STAFF REPORT

PLANNING & ZONING COMMISSION

1. FINAL DEVELOPMENT PLAN REVIEW

Applicant: Elite Land Title LLC & 75 Lincoln LLC
Location: 75 Lincoln Street
Zoning: DB, Downtown Business District
Request: To review a final development plan for a proposed 2,735 sq. ft. office building.

Figure 1

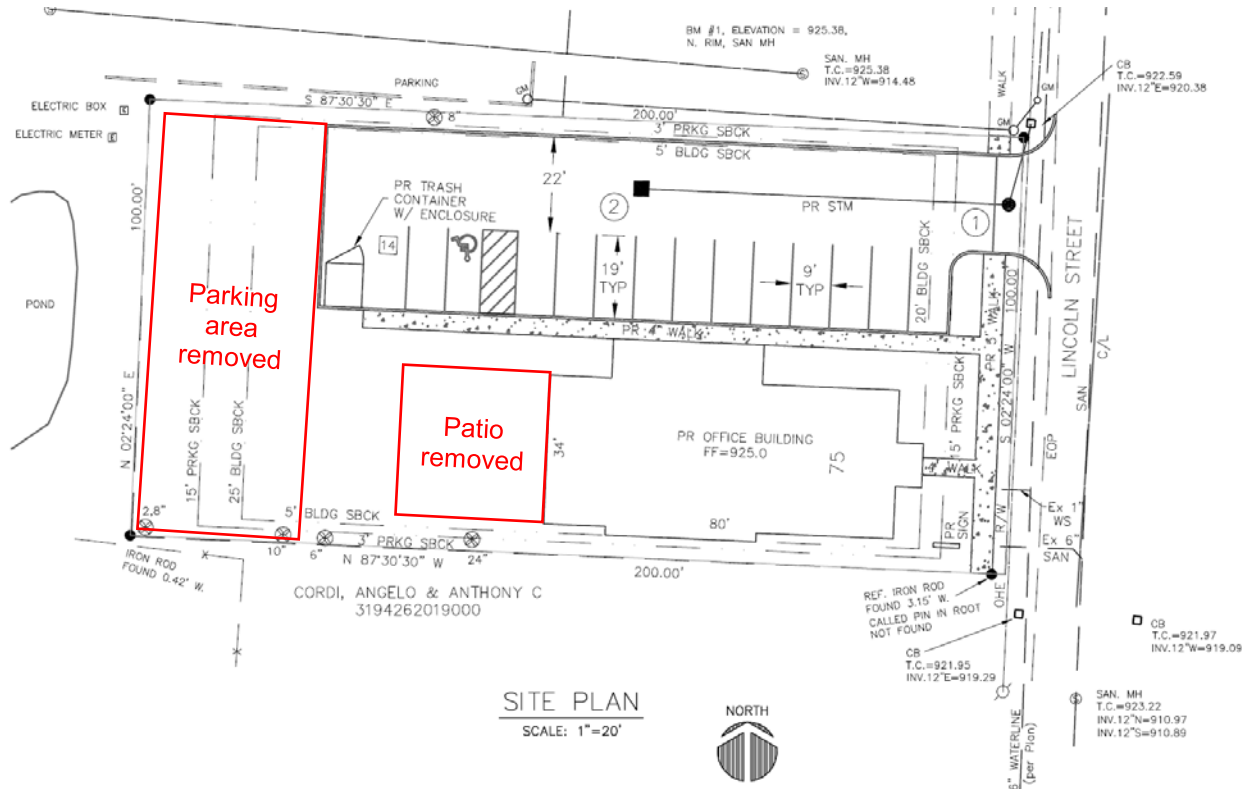
1. The parking lot behind the building and the patio were removed (Figure 1).
2. Additional grass was added to the site to account for the reduced parking and building size (Figure 2).

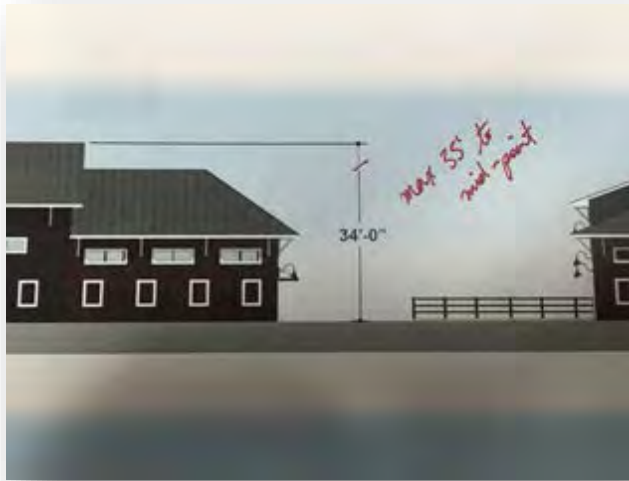
5. To alleviate any concerns about height and scale, the applicant provided a cross section of Lincoln Street to show how the proposed buildings are in relation with neighboring buildings. As can be seen from the figure below, the proposed building would be in scale with the nearby buildings heights.

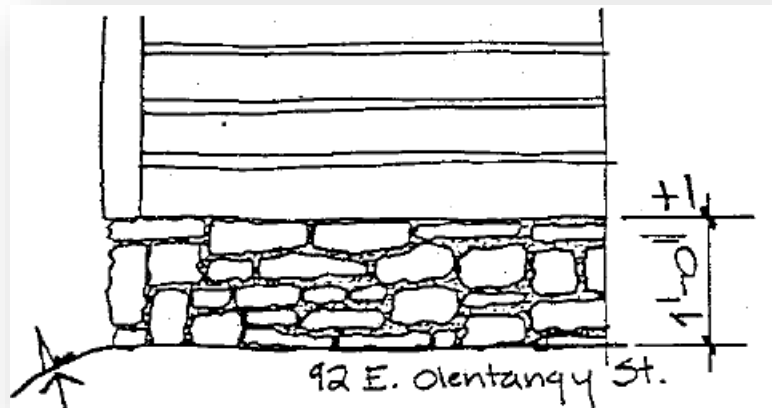
7. The applicant provided turning radius analyses for 40 and 53 foot trucks. To do a rough analysis, staff took the diagrams and superimposed them onto aerial imagery using GIS (the images are attached). Staff, along with the Acting City Engineer did a cursory examination of the images and determined the following:

- a. The Lincoln Street sides at West Olentangy Street will need to be improved to accommodate truck traffic. Improvements would include widening the throat and radius, moving the sidewalk back, possibly relocating the utility pole and restriping. Further details would be determined at a later date by the City Engineer if the plan were to be approved.

- b. A "Semis no right turn" sign will need to be installed to restrict turning onto Lincoln Street for westbound trucks.
 - c. Staff also determined that in the long-term, Lincoln Street may need to be widened and improved due to increased traffic and the development of the adjacent sites to the west and east and south of the subject site. At this time, however, the improvements are not necessary. Since this parcel is in the TIF district, if approved, the property development will increase the TIF fund that could ultimately be used to make the improvements. The neighboring vacant sites, when improved, would also pay into the TIF fund, which would

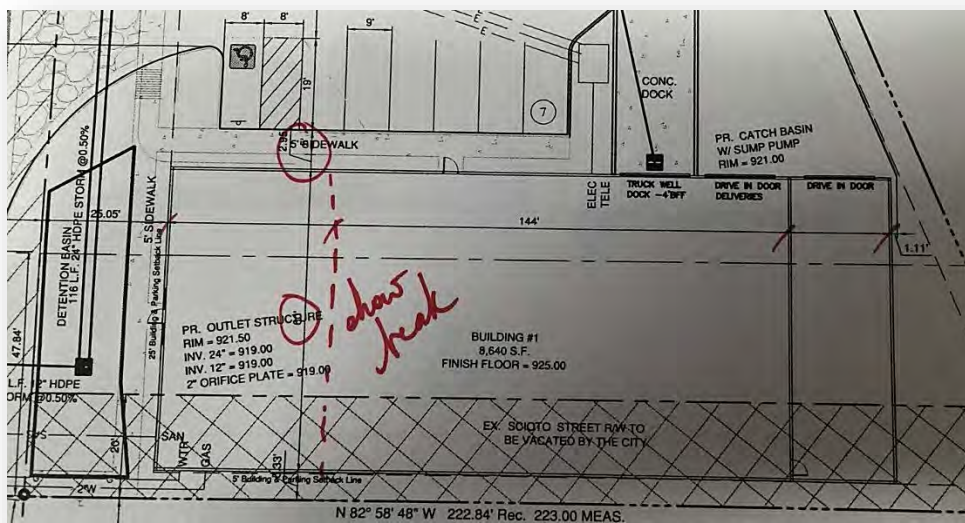
8. The applicant provided additional elevations for Building #1. After reviewing the new architectural drawing staff has the following comments:
 - a. The window style may need to be changed. As per the Architectural Guidelines, double hung windows with no grids are preferred. Also, the dimension of the windows may be incorrect. Dimensions of windows should also be reviewed in the Architectural Guidelines.
 - b. Staff suggests adding a small, stone veneer foundation to the bottom of each proposed building. Stone foundations are typical for barns, the style these buildings are aiming to mimic (see example below).
